X 95.002-26

Model 250PS

Sealing ring and pressure relief valve on the hydraulic motor

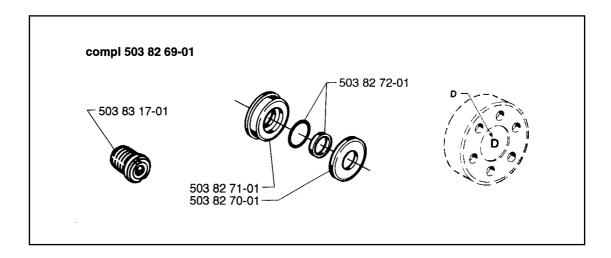
To meet the application requirements for the valve unit on skylifts, etc. the hydraulic motor on all pruning saws shafts will be fitted with a special hydraulic seal. At the same time the pressure relief valve will be replaced by one with a greater opening pressure. This modification is made in case of higher pressure on the return side, which can occur when the pruning saw shaft is used together with an external power source and valve unit. The modified pressure relief valve opens at 40 bar compared to the old which opened at 20 bar. The hydraulic motors fitted with a hydraulic seal and modified pressure relief valve are marked with a D on the pump housing's end plate, see figure.
